**DOCUMENT 00 90 00
ADDENDUM**

ADDENDUM NO. [1] Date: August 14, 2019

**RE: LANESBORO PUBLIC SCHOOLS
 ADDITION AND REMODEL
 100 KIRKWOOD ST EAST
 LANESBORO, MN 55949
 HSR 18063**

**FROM: HSR Associates, Inc
 100 Milwaukee Street
 La Crosse, WI 54603
 (608) 784-1830**

E121P

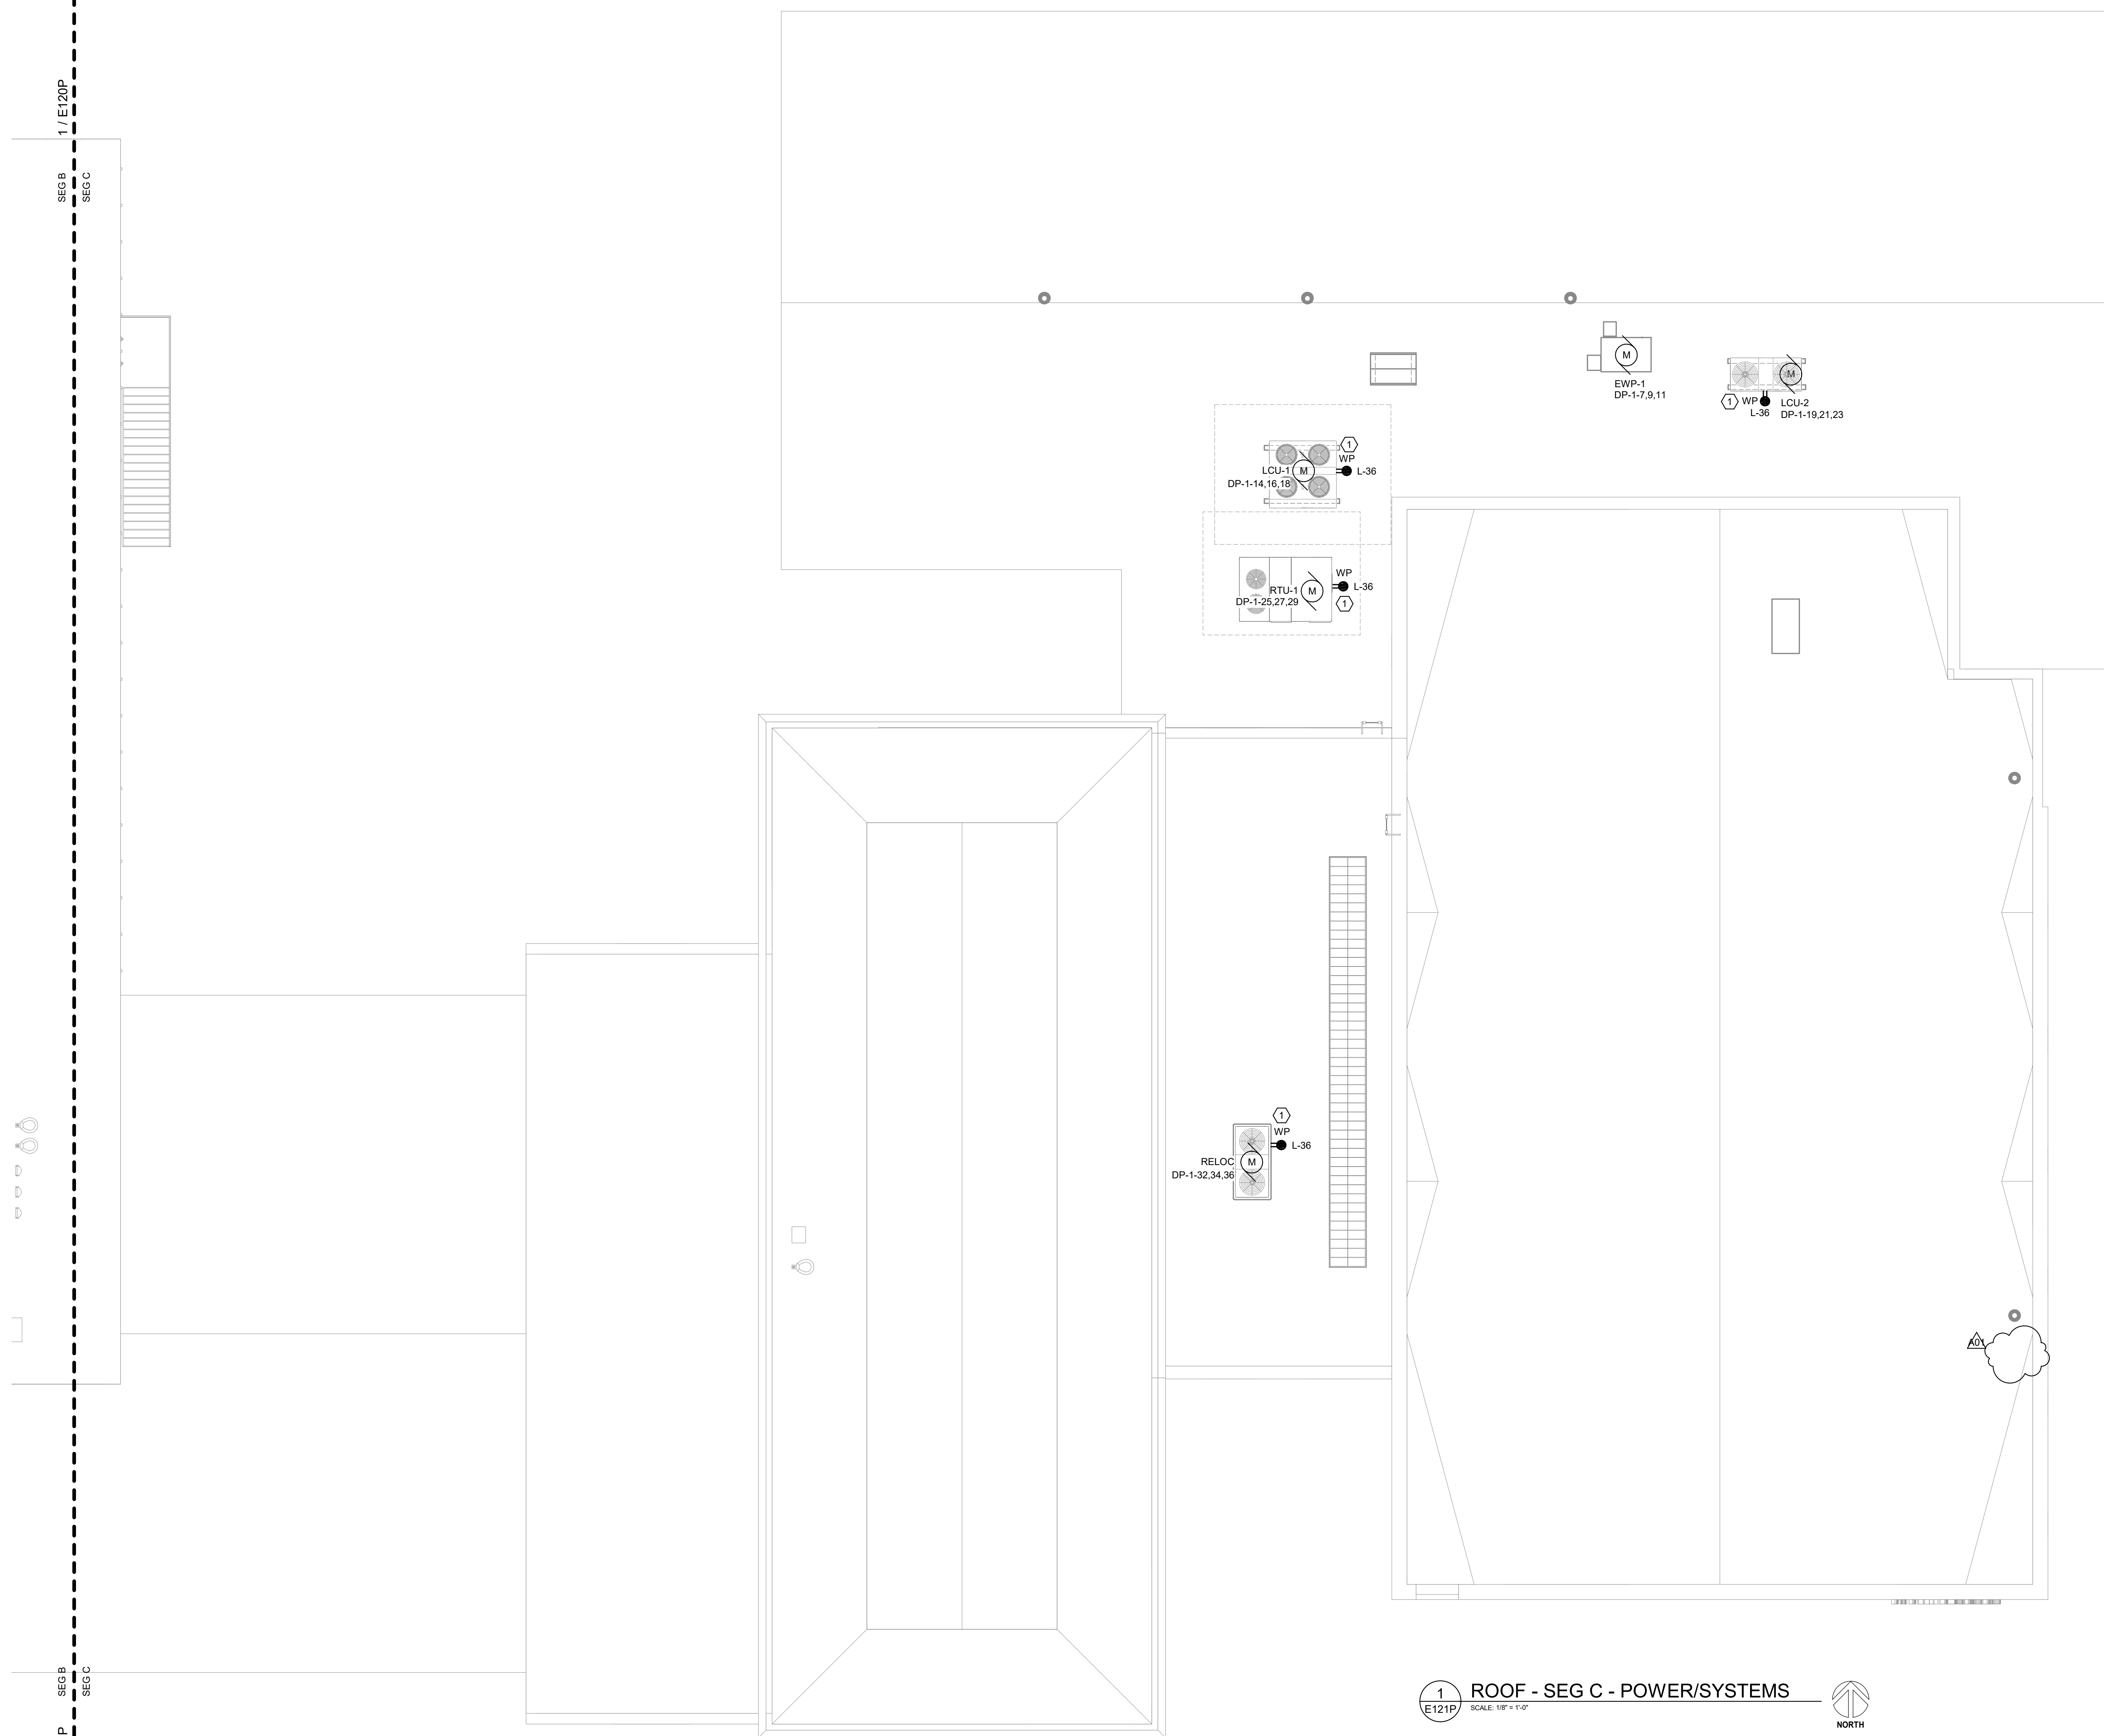
- b. Remove devices not located on roof, as shown.
61. Sheet E121P ROOF PLAN – SEGMENT C – POWER/SYSTEMS 30 x 42 attached hereto
 - a. Revisions clouded on Drawing.

- b. Remove devices not located on roof, as shown.
62. Sheet E800 SCHEDULES – ELECTRICAL 30 x 42 attached hereto
 - a. Revisions clouded on Drawing.
 - b. Revise HVAC & Plumbing equipment schedule, as shown.
